REQUEST

Current Zoning: I-1 (light industrial)
 Proposed Zoning: I-2(CD) (general industrial, conditional)

Approximately 4.34 acres located at the end of Cressida Drive, near the intersection of South Boulevard and East Westinghouse Boulevard.
 (Council District 6 – Bokhari)

SUMMARY OF PETITION

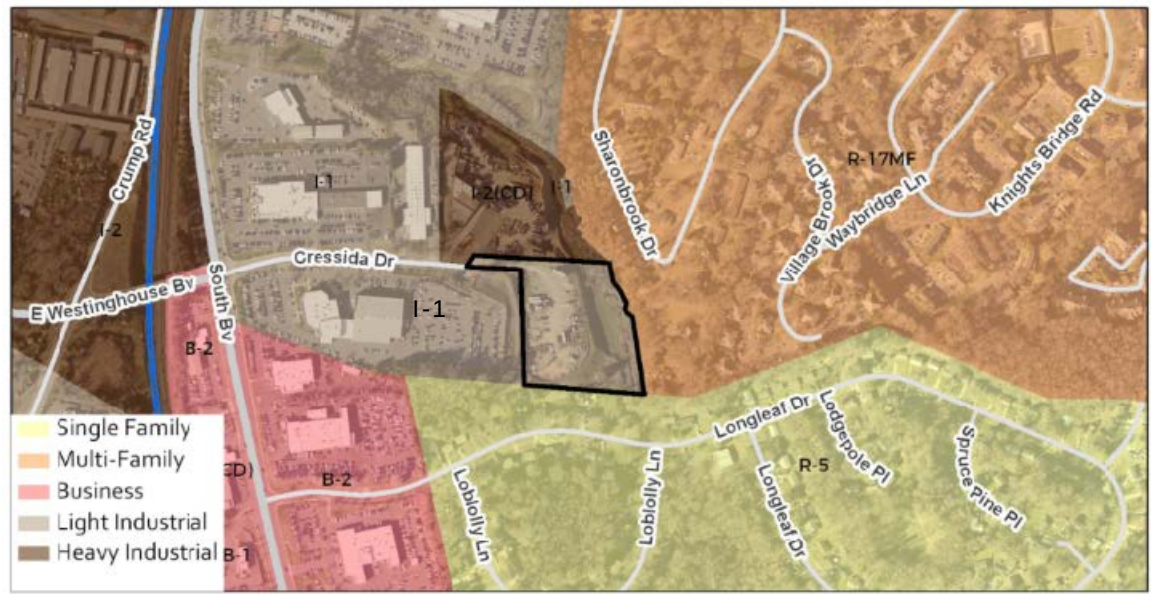
4. Remove the 10-foot setback/rear yard label from the site plan (top right corner) as the buffer line and building/parking envelope will take precedence. **Addressed.**

5. Revise the site plan and conditional note(s) to include eight foot planting strip and six foot sidewalk on the frontage of the site not occupied by driveway(s). **Addressed.**
